# HISTORIC DISTRICT COMMISSION NOTICE OF DENIAL

**Application Number:** HDC2025-00112

<b>NAME:</b> Alexandra Sawa		<b>COMPANY NAME:</b> My Big Fat Shawarma	
<b>ADDRESS:</b> 30800 Telegraph Rd. Suite 1724	<b>CITY:</b> Bingham Farms	<b>STATE:</b> MI	<b>ZIP:</b> 48025
<b>PROJECT ADDRESS:</b> 4704 Anthony Wayne Drive			
<b>HISTORIC DISTRICT:</b> Warren-Prentis

Install new grey brick (work completed); install EFIS; paint exterior cladding

**BEFORE**

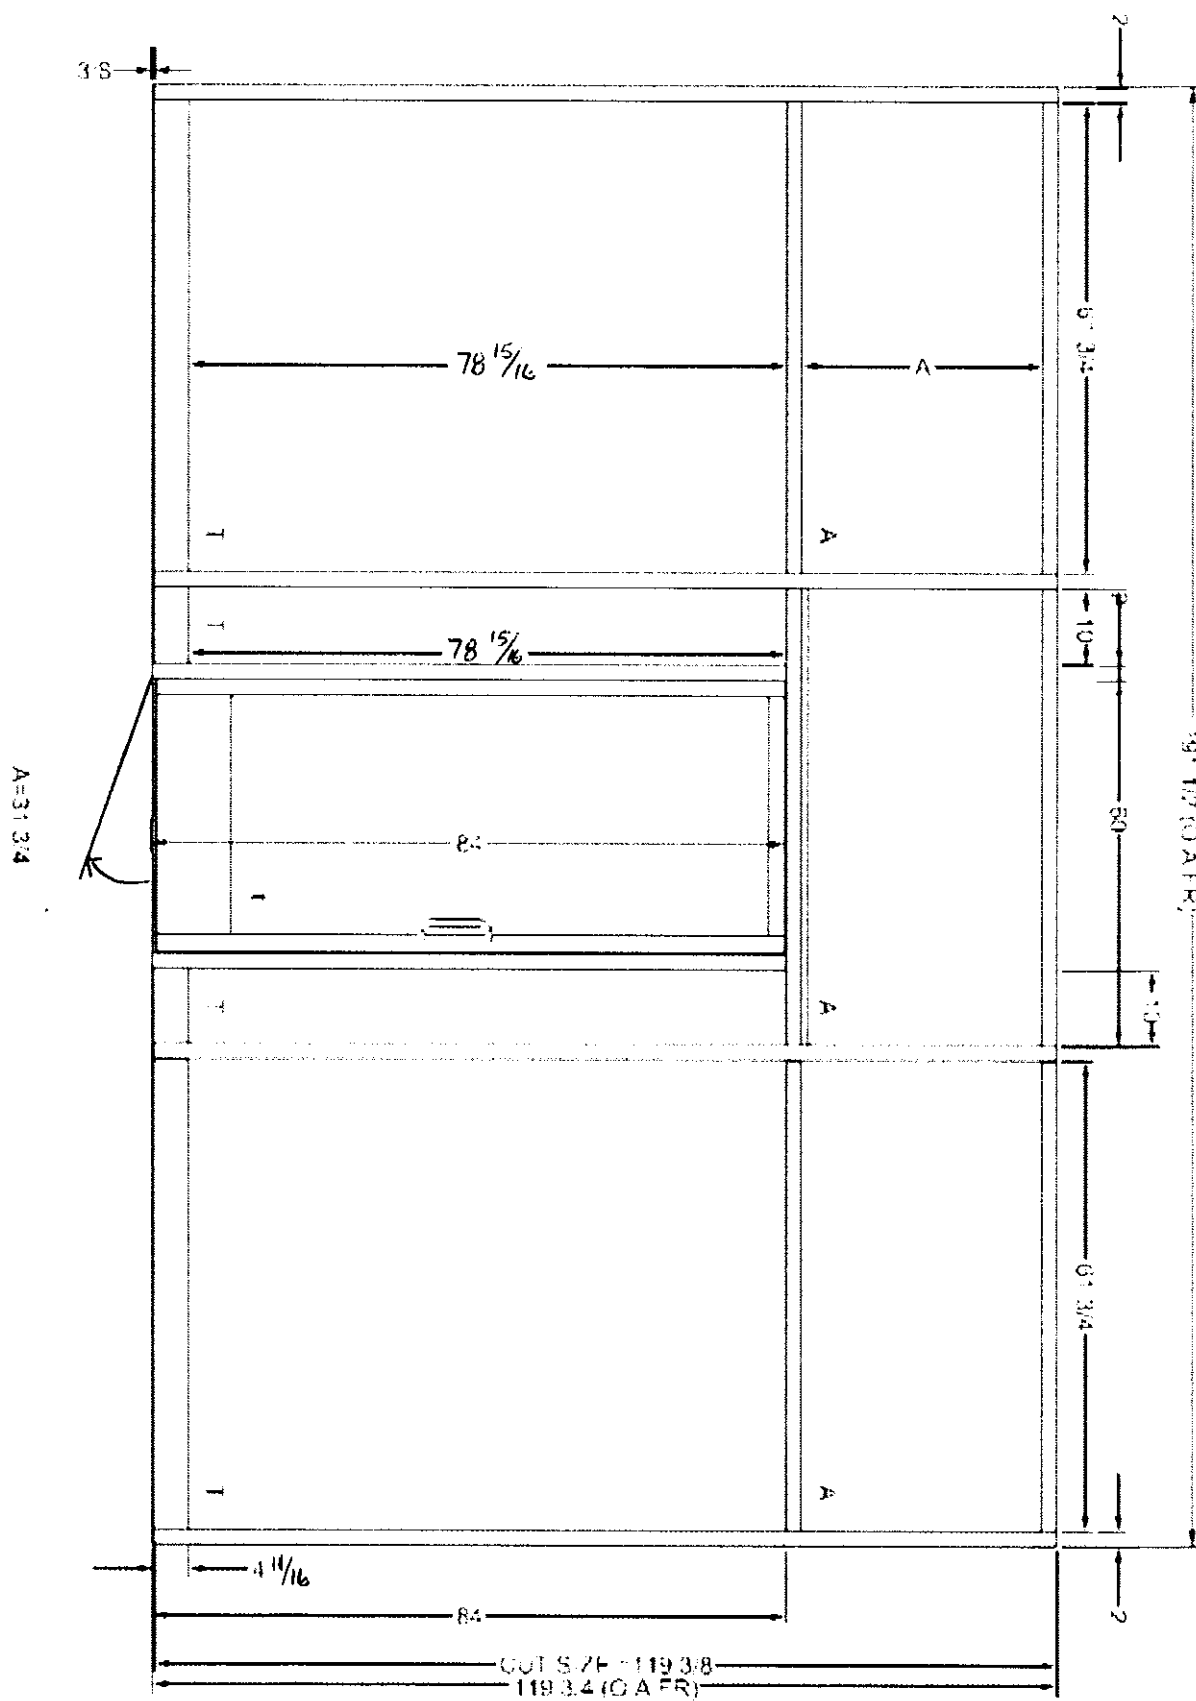
- The current application does not include documentation that the brick cladding which was replaced was deteriorated beyond repair, and the current gray brick that was installed without approval is not appropriate to the building's historical character. It is not an adequate match of the original in texture, dimension, bond or color. Also the herringbone pattern and design, and the limestone band below which once existed at the parapet has not repeated with the current recladding. As a result, the current storefront appears incongruous with the remaining portions of the building's front and side facades .
- The EFIS proposed for the building in the permit drawings is also an inappropriate cladding because it is not an adequate replication of the brick which is removed. Also, the painting the entirety of the new brick, the storefront will obscure the bricks' character.
